STAFF REPORT 09-11-2019 REGULAR MEETING

APPLICATION NUMBER: 19-6412

ADDRESS: 1793 SEYBURN STREET

SCOPE: REHABILITATION OF BUILDING

1915 SANBORN MAP

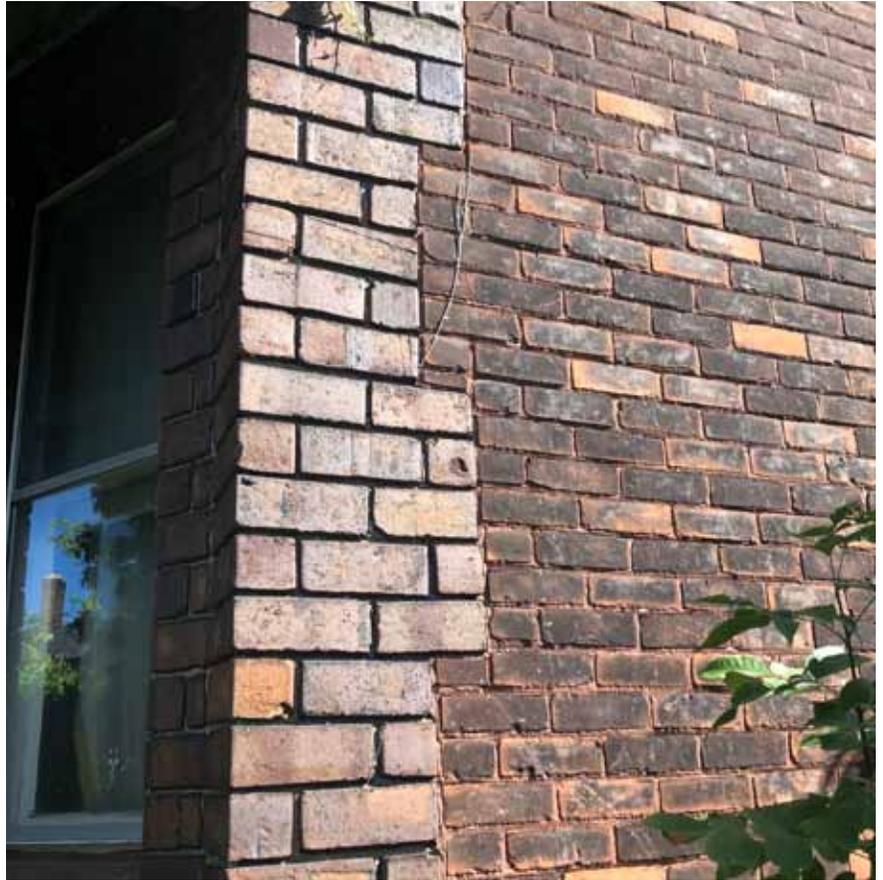
- The existing rear porch is not visible from the right-of-way.
- The rear porch was constructed as part of the home originally (see Sanborn map).

detailed photos of porch to be demolished

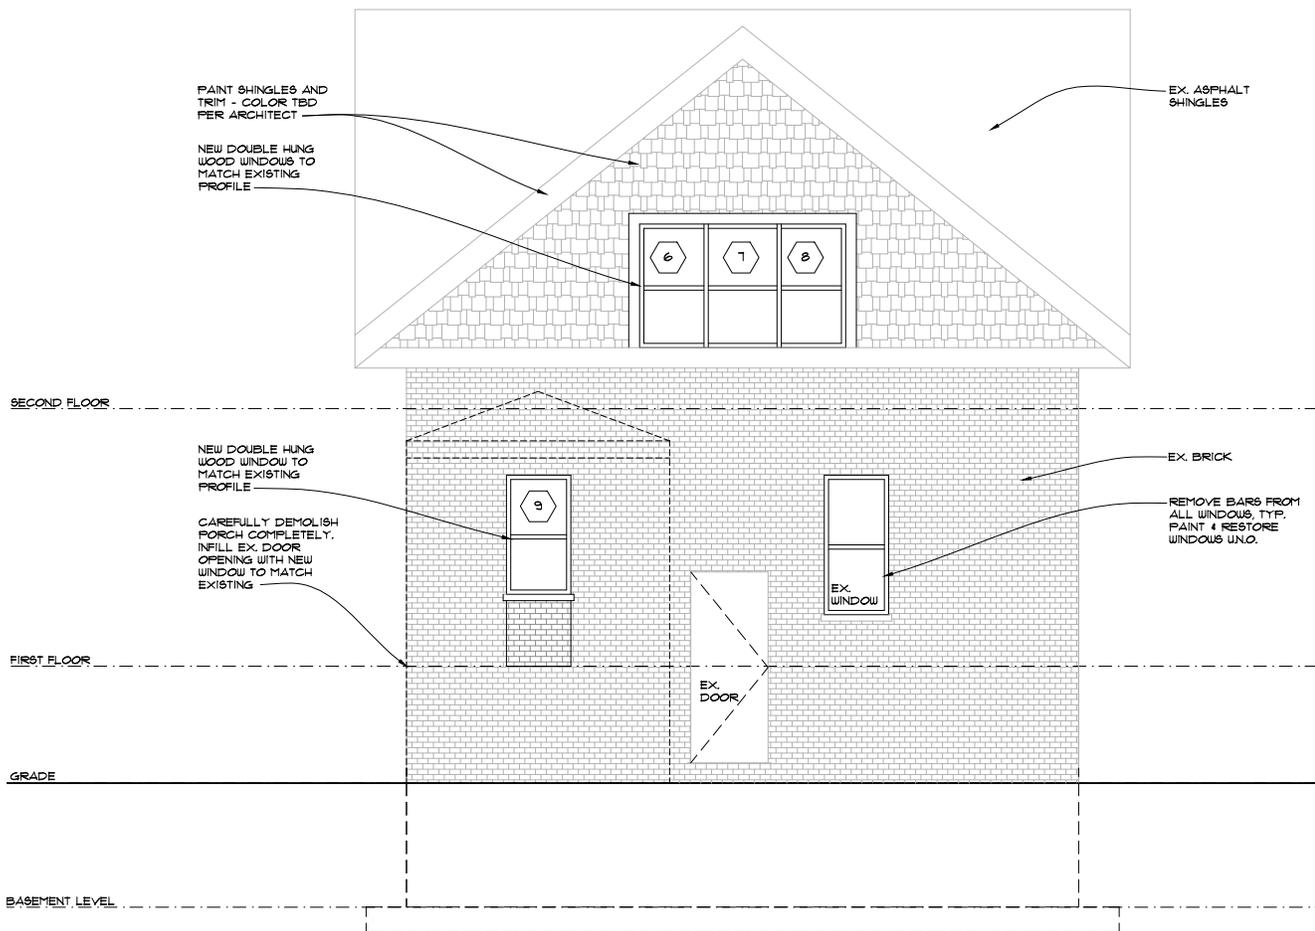
- ***Demolish rear porch in its entirety and replace existing door with new wood window and brick knee wall infill***
- ***Replace all (7) existing second story wood double-hung windows***

It is staff's opinion that the work, as proposed, destroys historic materials that characterize the historic building, its site, and setting. Staff therefore recommends that the Commission find the scope items listed above to be inappropriate as the scope of work does not meet the following Secretary of the Interior's Standards for Rehabilitation:
